Planning Commission Meeting

Meeting Date: Tuesday, March 19, 2019

5.3. 18-047 DR/VAR/ADJ Sandy Vault Self Storage 41 - 243

SANDY VAULT A SELF STORAGE FACILITY DESIGN REVIEW CHAMPION WAY, SANDY, OREGON 97055

E16-055 GRADING PLAN EAST.dwg 14:27 01/03/2019

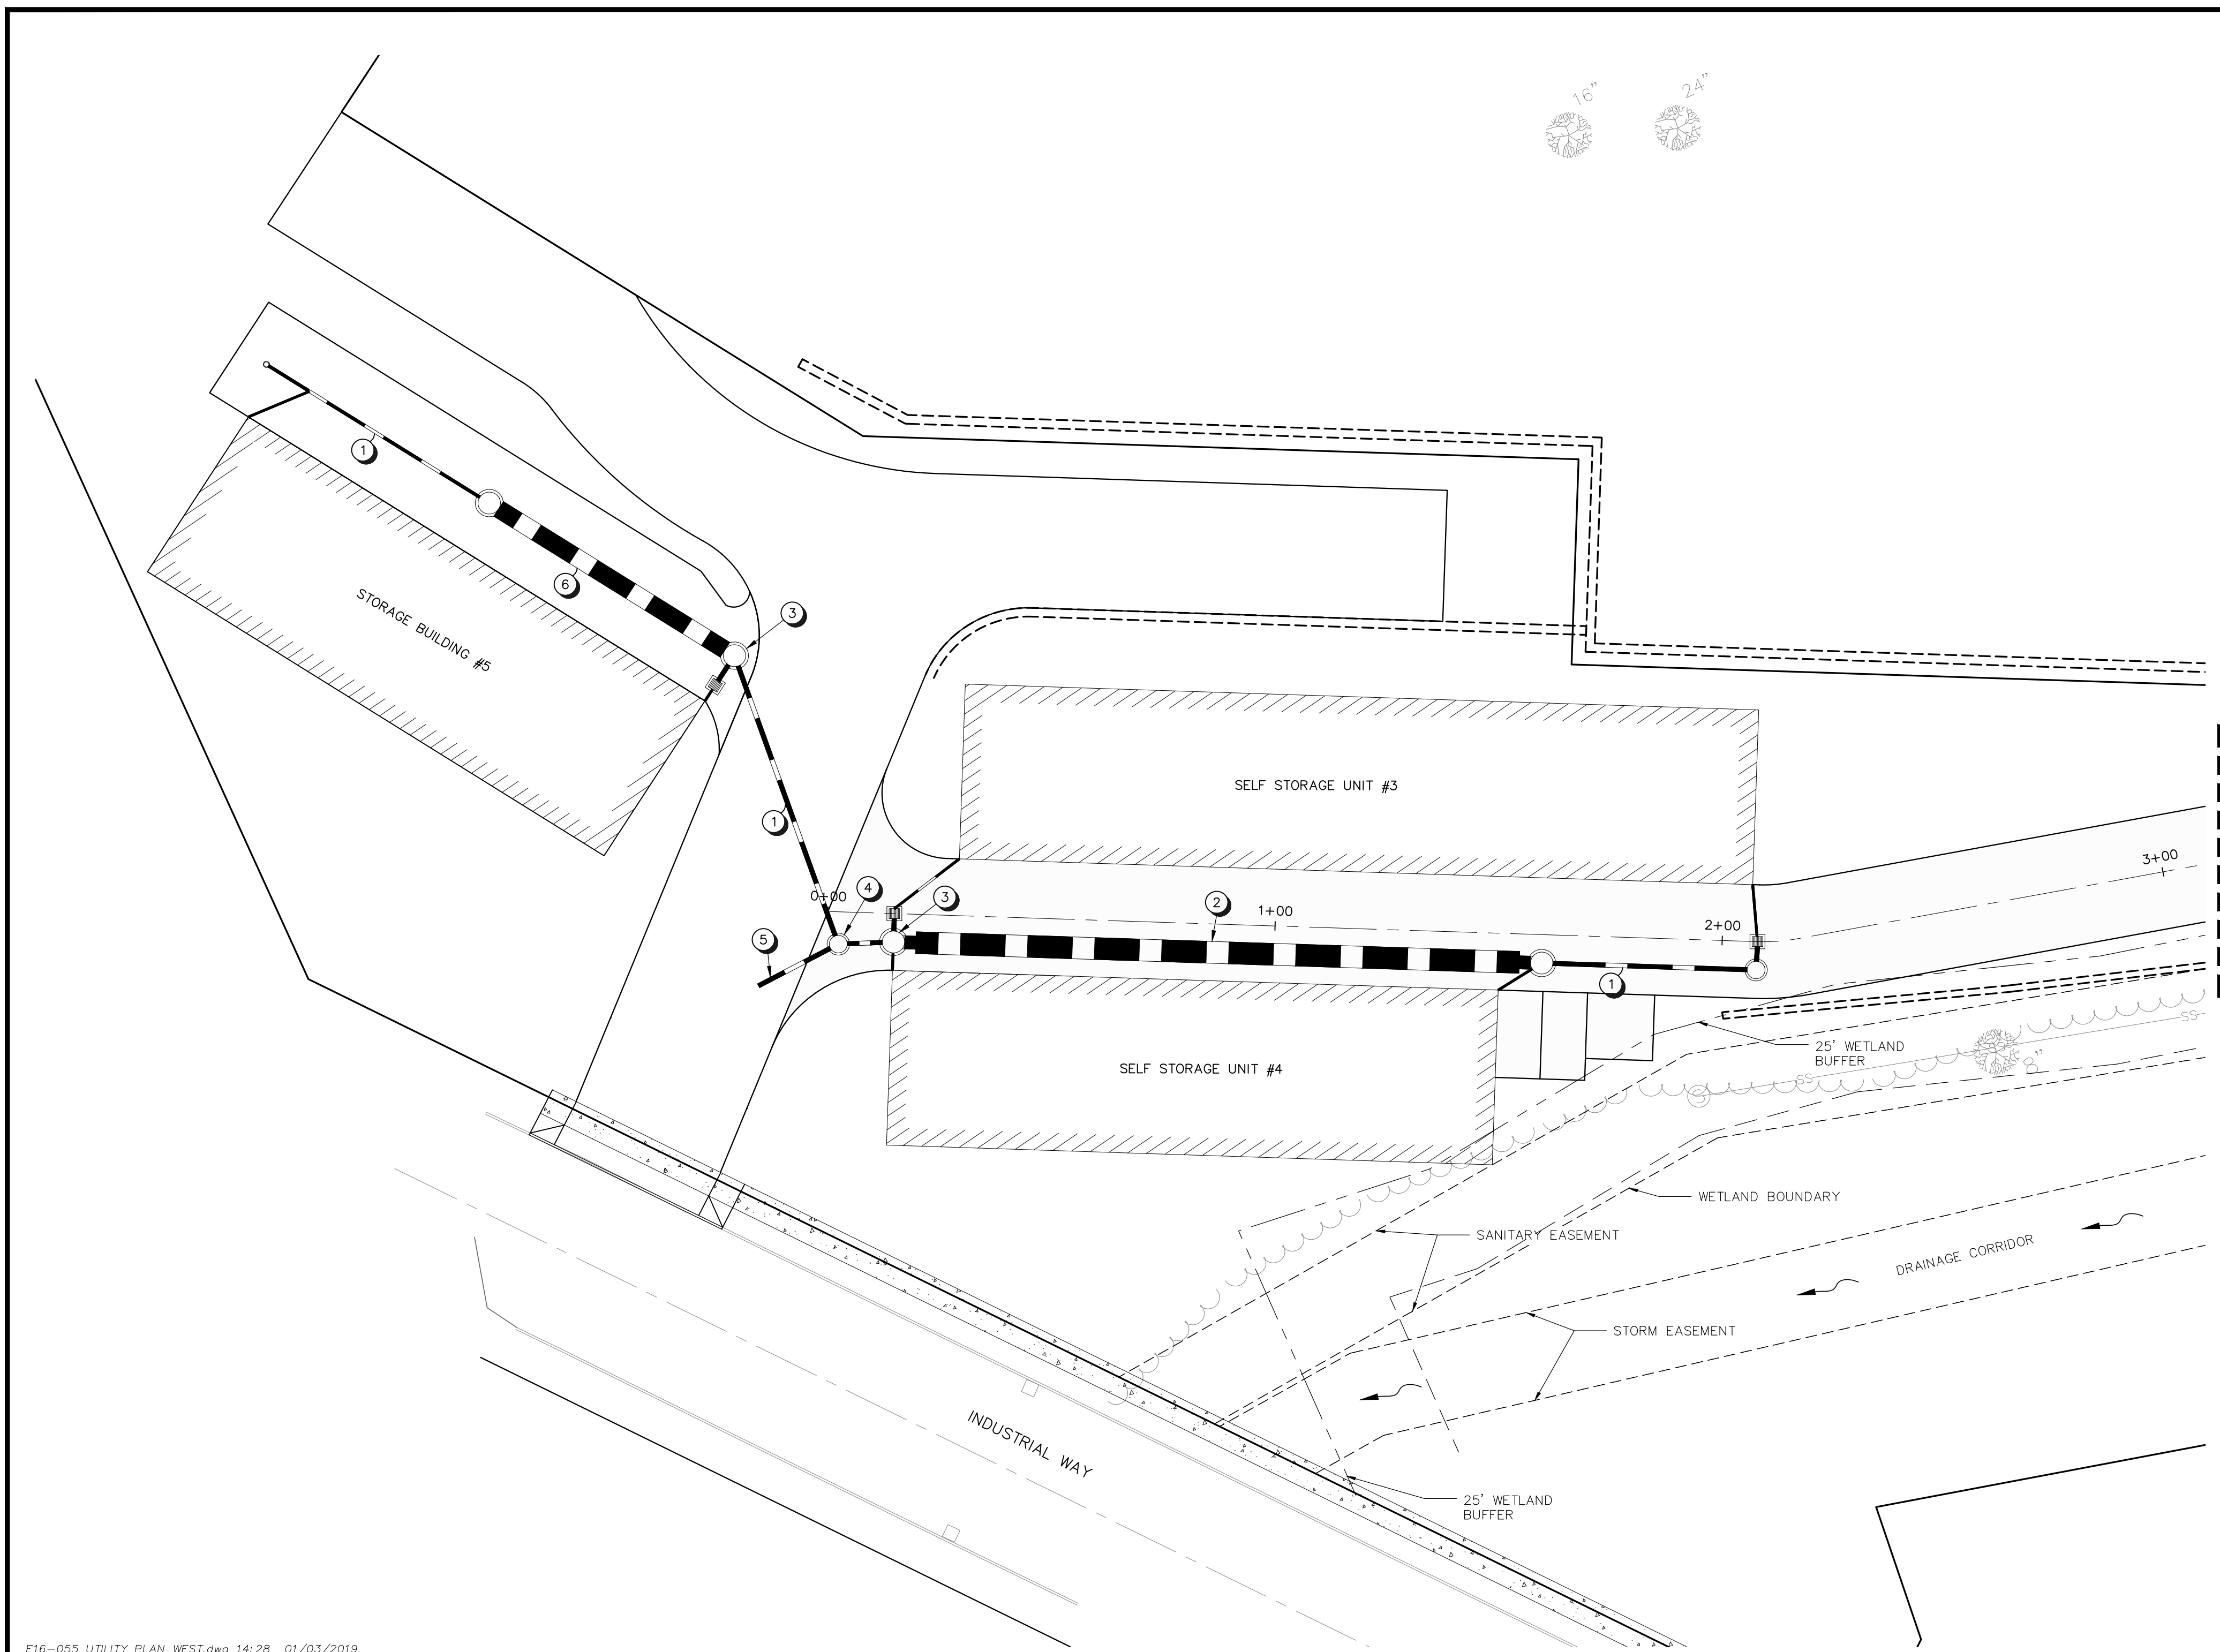
RESPONSE: *The site has existing topography that slopes away from Highway 26. The submitted Grading Plan (Exhibit C, Sheet 6) shows the location of the proposed retaining wall along Champion Way as well as proposed re-grading of the site. The applicant’s deviation, adjustment, and variance narrative (Exhibit B) states: “Since it is constructed perpendicular to the slope of the land, the wall will step down and thus the maximum height of 8’-6” (Approx.) will only occur at the end of each step and the average height of each segment will be lower.” The Grading Plan with retaining wall details (Exhibit C, Sheet 6) includes an elevation of the proposed terraced wall and confirms that a majority of the wall will be less than 6 feet in height, with only one terraced segment exceeding 6 feet in height. Thus, staff believes the wall design does not violate the intent and purpose of the retaining wall height requirements nor will it be materially detrimental to the public welfare. Criterion A is met. Per the narrative, “The area supported by the retaining walls will be terraced and landscaped in an attractive manner as shown on the Landscape Plan. Additionally, the wall itself will be constructed of an attractive, architectural material keyed to the building facades.” **The applicant shall submit proposed architectural treatment for all exposed sections of the retaining wall for staff review and approval.***

E16-055 UTILITY PLAN EAST.dwg 14:28 01/03/2019

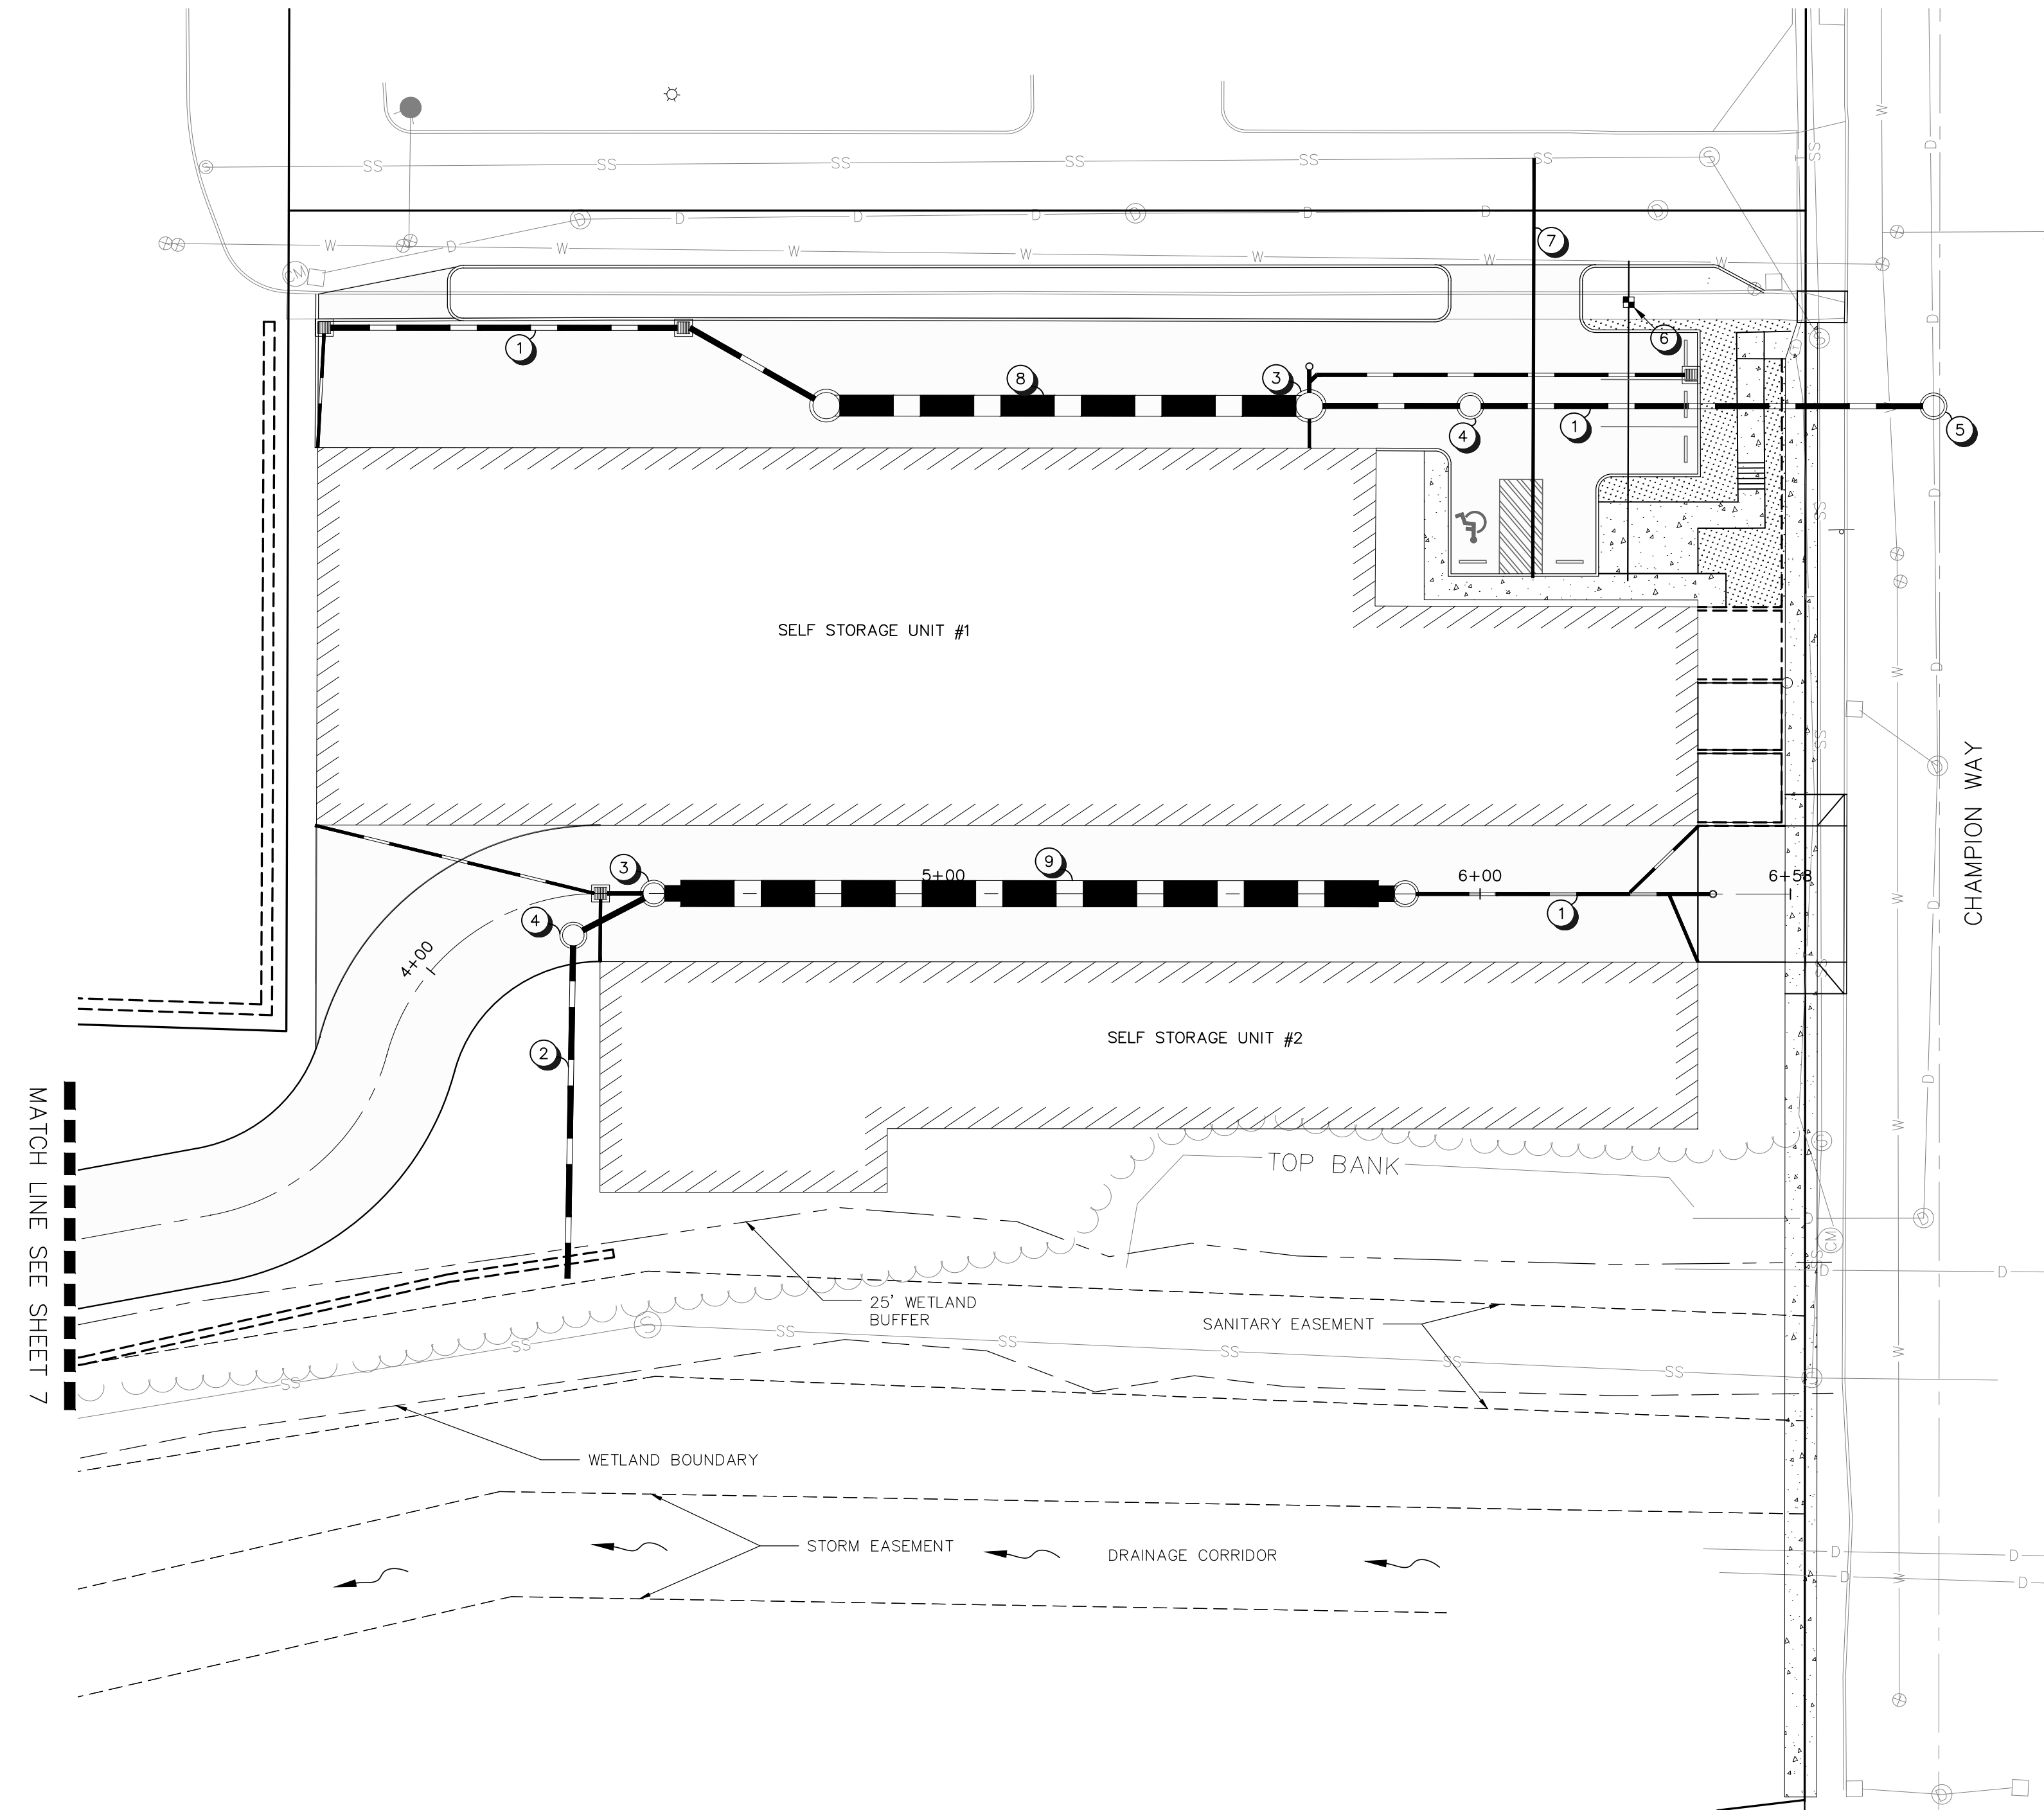
*Per the Public Works Director (Exhibit M), the Utilities Plan East (Exhibit C, Sheet 8) shows a water service connected to the private water main in the common access easement. Water service laterals may only be connected to public water lines. **The water service for the site shall be connected to the public water main in Champion Way.** The Utilities Plan also depicts a sewer lateral connected to the existing private sewer main in the common access easement. **The applicant shall sign and record a sewer maintenance agreement reviewed and approved by the City for multiple properties under separate ownership served by a private common sewer line. All stormwater detention and treatment shall conform to the requirements of Sections 13.18 and 13.20 of the SMC and the City of Portland Stormwater Management Manual (SWMM). Prior to beginning design on the utility service lines the applicant shall consult with Sandy Fire District regarding fire hydrant locations and spacing on the site.***

- The utilities plan East (sheet 8) shows a water service connected to the private water main in the common access easement. Water services may only be connected to public water lines. The water service for the site shall be connected to the public water main in Champion Way.
- Sheet 8 also depicts a sewer lateral connected to the existing private sewer main in the common access easement. The applicant shall sign and record a sewer maintenance agreement reviewed and approved by the City for multiple properties under separate ownership served by a private common sewer line.
